# DAUPHIN COUNTY SUBDIVISION/LAND DEVELOPMENT REVIEW REPORT

Plat Title: G. Morris Solar LLC C/O Birch Creek Development, LLC

Proposed Land Use: Major Solar Energy System

Purpose: Proposed Major Solar Energy System (MSES) & Two Lot Subdivision

# EXISTING CONDITIONS AND DEMOLITION PLAN 1

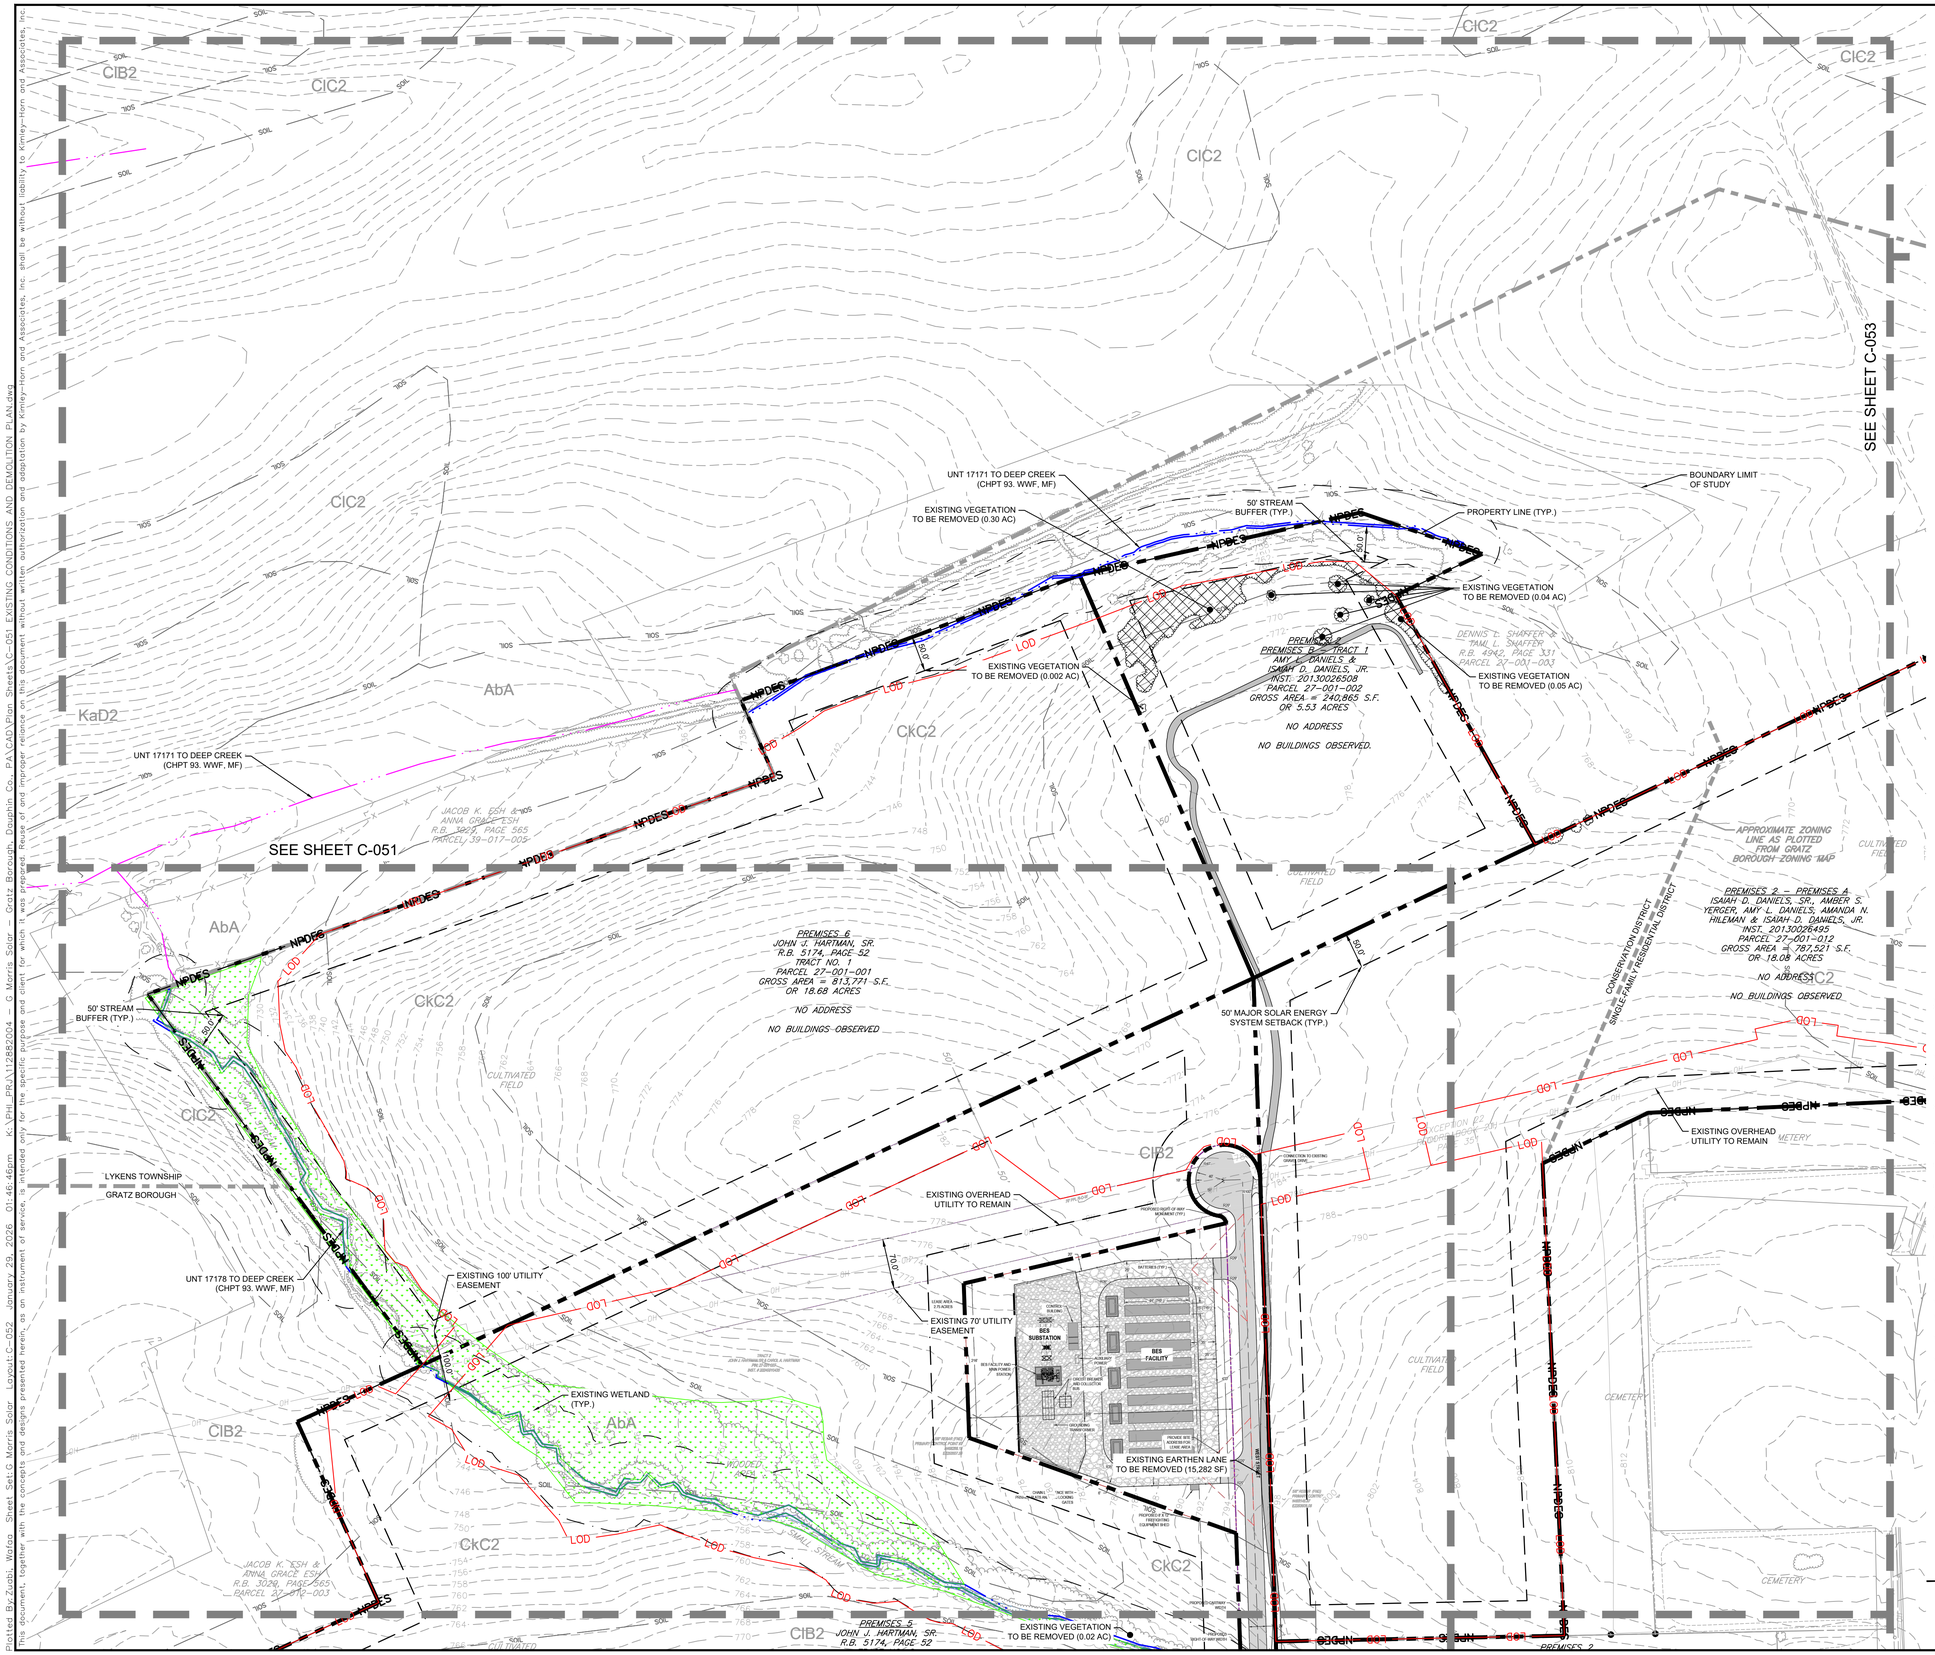
7. The proposed lot coverage needs to be shown to ensure it is in compliance with §504 of the Zoning Ordinance.
8. Plan Sheet C-051 indicates that tax parcel 27-001-007 is being subdivided by creating Proposed Lot 4 and Proposed Lot 4A. Plan Sheet L-101 shows these lots being combined into one parcel. It needs to be clarified if these lots are being subdivided or combined.

37. Note #13 on Plan Sheet C-051 states that any sign removed or damaged by the contractor will be replaced by the Borough. This note should be changed to stated that the Contractor will replace any removed or damaged sign.
